IPC

New Material Submission for Harbourside Redevelopment

Views from One Darling Harbour to the west face of the proposed development

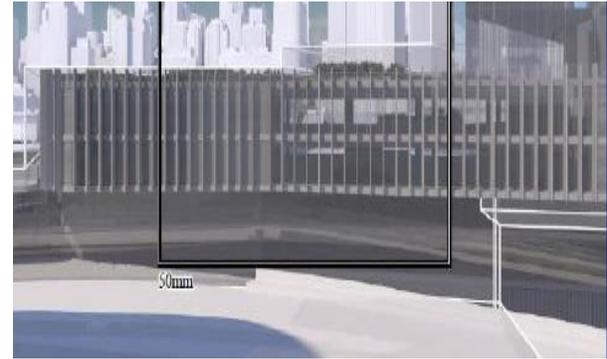
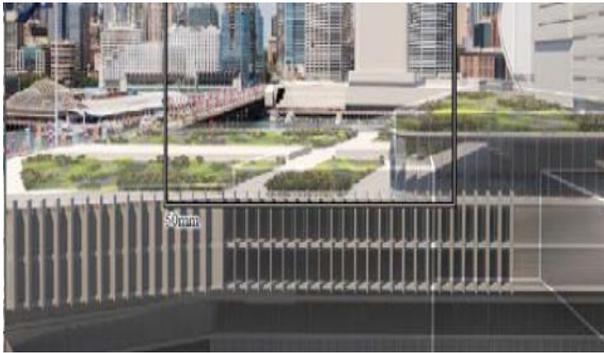
The Mirvac Option is marginal at best and still insisting on a massive podium which unreasonably impacts on the surrounding area and is not commensurate in bulk and scale with neighbouring Cockle Bay redevelopment providing two inconsistent character of addressing the Cockle Bay basin as well as an inconsistent start and end of the Pyrmont Bridge. The proposal still has a podium starting at RL of 13.75 and only extends 25m from Pyrmont Bridge before rising to RL 21.5 which is nearly twice as high as the Cockle Bay Redevelopment northern Podium RL12 and the Pyrmont Bridge RL 11.8.

My highly valued water views and land water interface views are little changed. There is not attempt to provide view sharing and I still be staring at what looks like a car park façade.
